**HISTORIC PRESERVATION BOARD
CITY OF PORTLAND, MAINE**

**WORKSHOP
3 SPRING STREET**

**HISTORIC PRESERVATION BOARD
CITY OF PORTLAND, MAINE**

**WORKSHOP
DEERING STREET**

FLOOR PLAN: STREET LEVEL DECK PROPOSAL

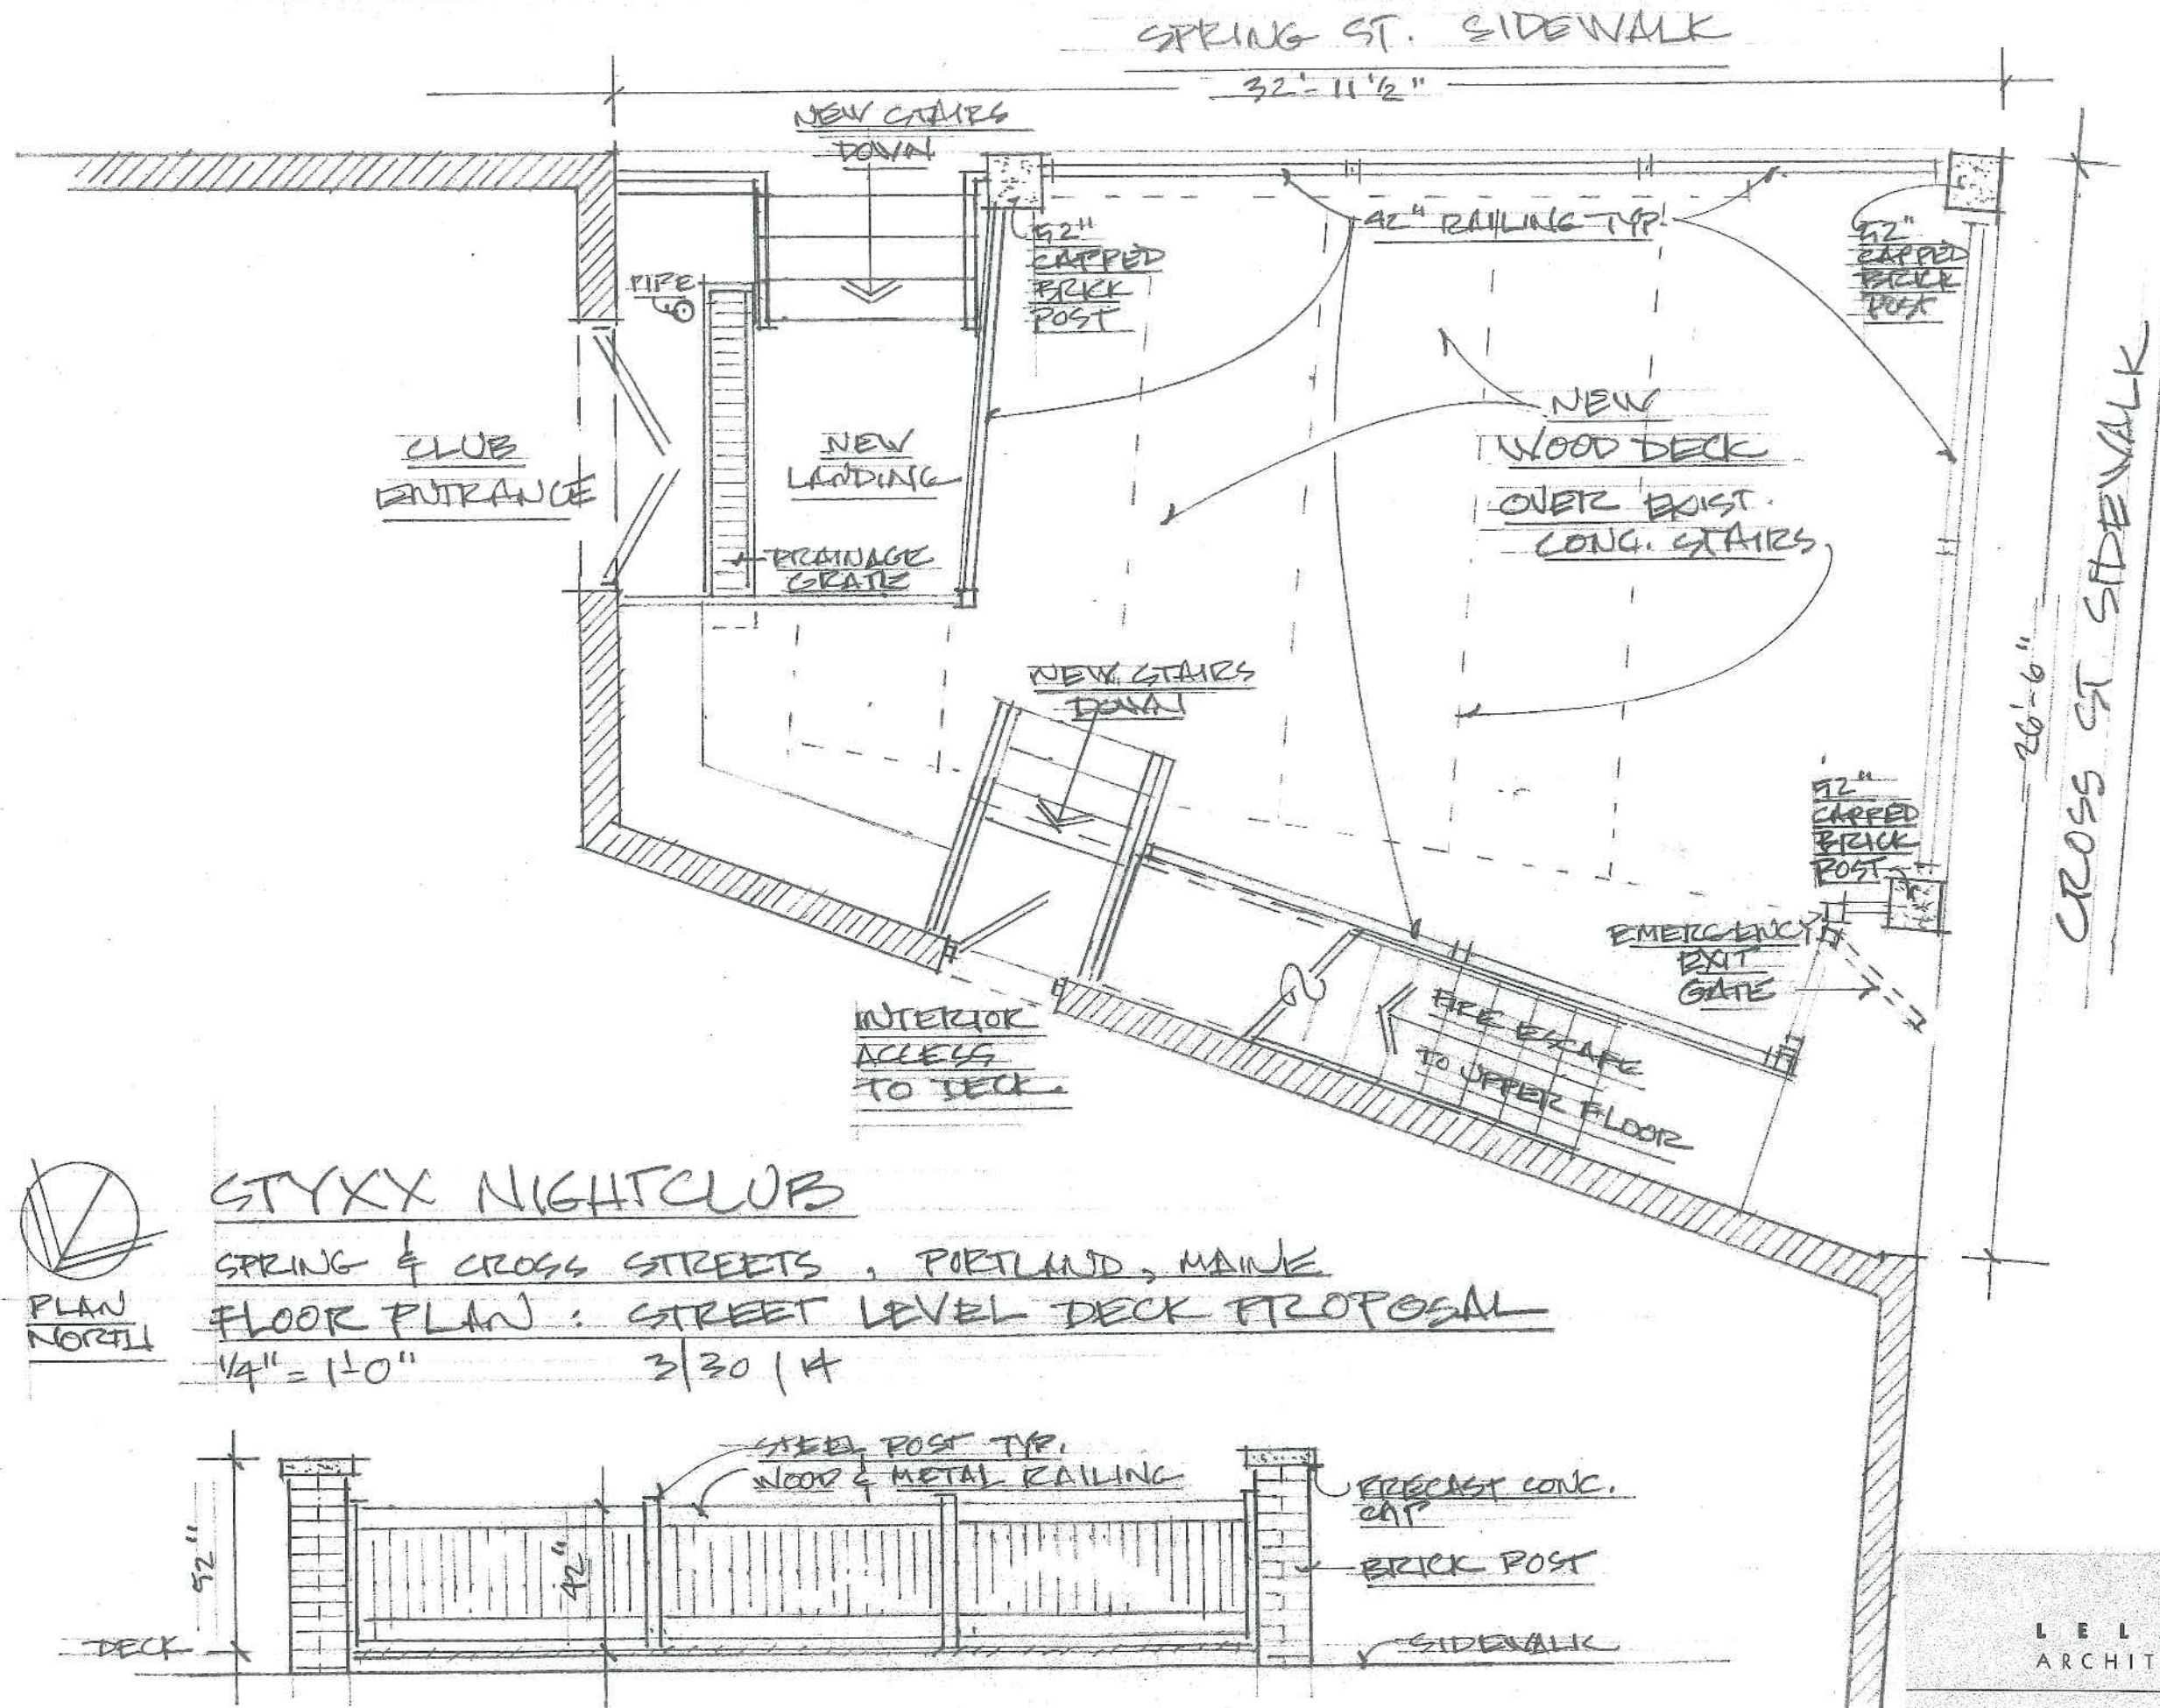
As with all projects of this type, the Board will want to consider the overall design relationship of the proposed addition to its immediate context, as well as the appropriateness and quality of specific details and material selections. In this instance, it is important that the fence solution relate to the relatively contemporary nature of the building addition it adjoins. If the fencing is to include brick piers it will be important that the bricks themselves and the masonry construction match to the extent possible the character of the building's masonry.

With respect to the deck itself, the proposal calls for pressure-treated decking. The Board will need to determine whether this will provide a sufficiently "finished" appearance in this urban location or if another decking material would be preferable.

In reviewing the proposed project, the Board might wish to inquire whether any improvements are being considered for the entrance itself. Given the nightclub use, it is likely that the applicant prefers to retain solid entrance doors, but further consideration might be given to the treatment of the door surround. With modified trim details, the entrance could be given a bit more architectural presence.

LANDSCAPE PLAN - MELLEN TO STATE STREET

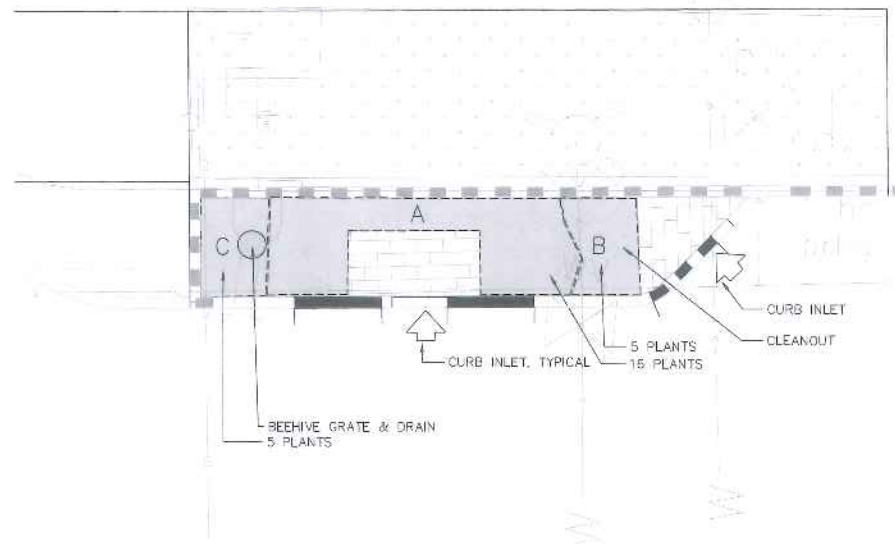
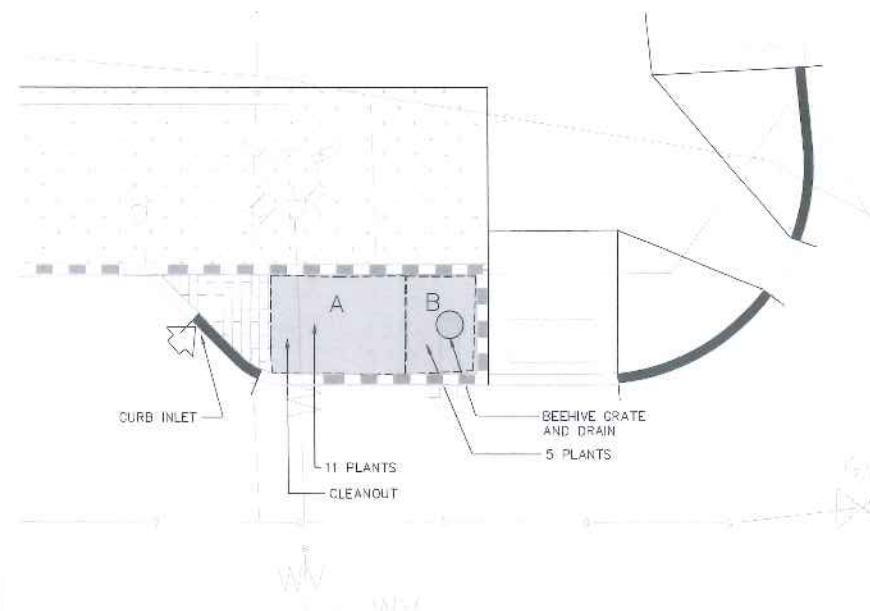
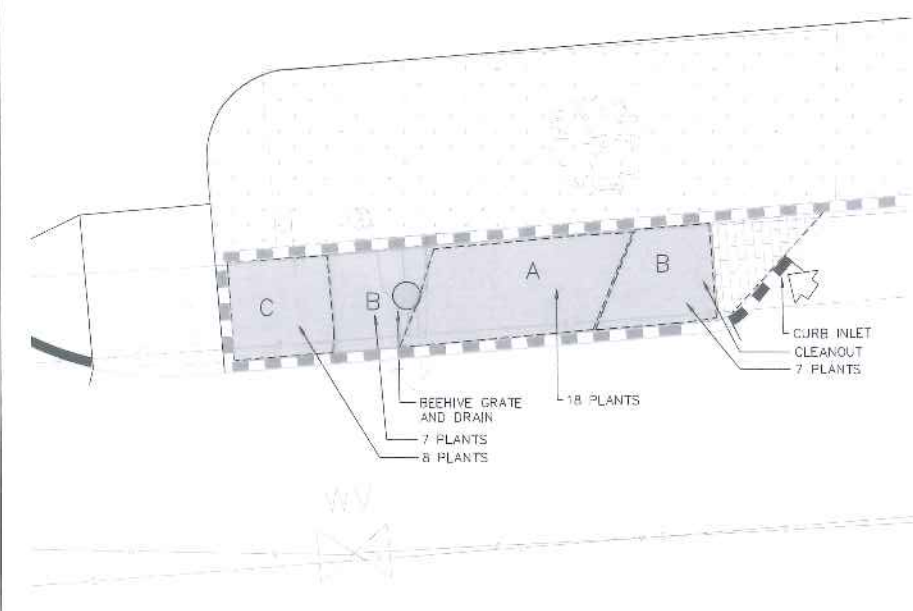
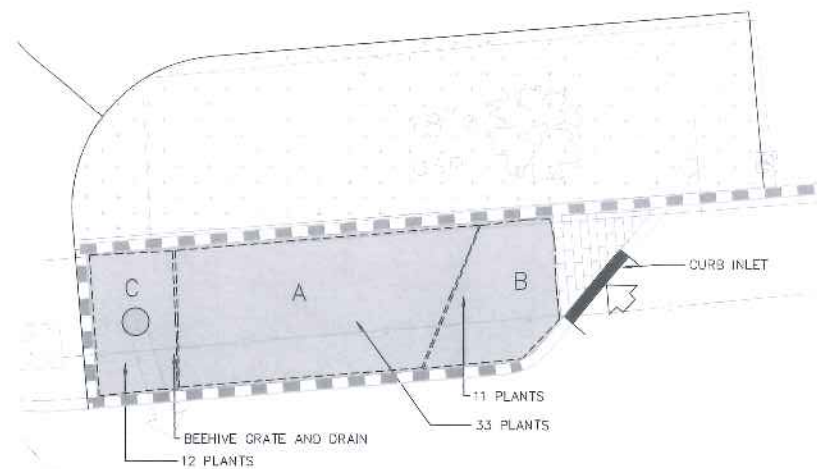
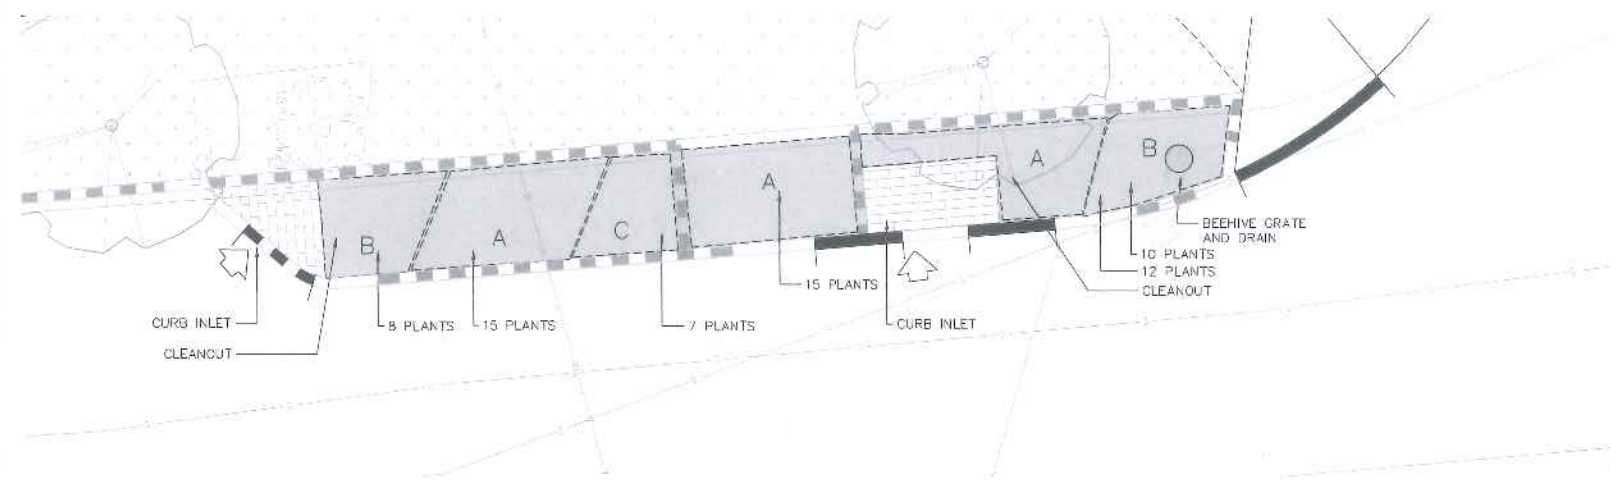
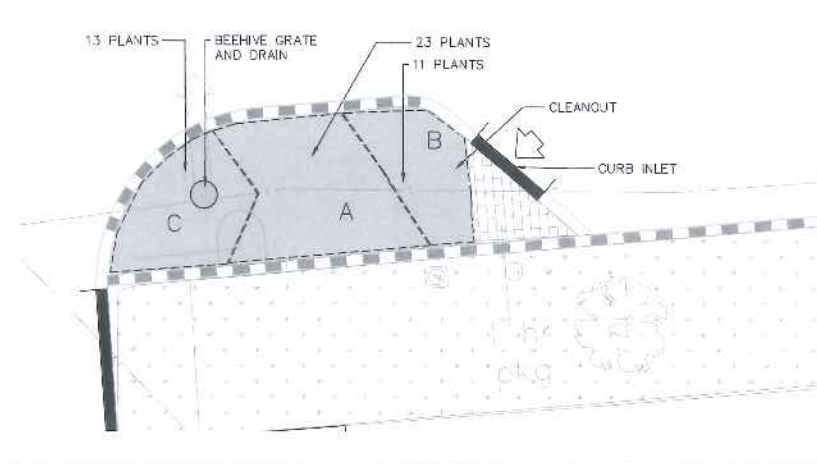
In reviewing the proposed streetscape improvements, the Board's role is to ensure that the character-defining elements of the existing streetscape are preserved to the extent possible and that any new interventions, such as the planted filter beds, not unduly alter the overall historic character of the street. Regarding the proposed replacement of granite curbing, the Board may wish to consider whether wholesale replacement is necessary and/or desirable. In a number of previous reviews of streetscape improvement projects, the Board has encouraged retention of original or historic material whenever possible. New, thinner granite curbing, especially in combination with the City's new brick specification (which yields a more matte and uniform overall appearance to the sidewalk) may represent a greater departure in character than desirable.
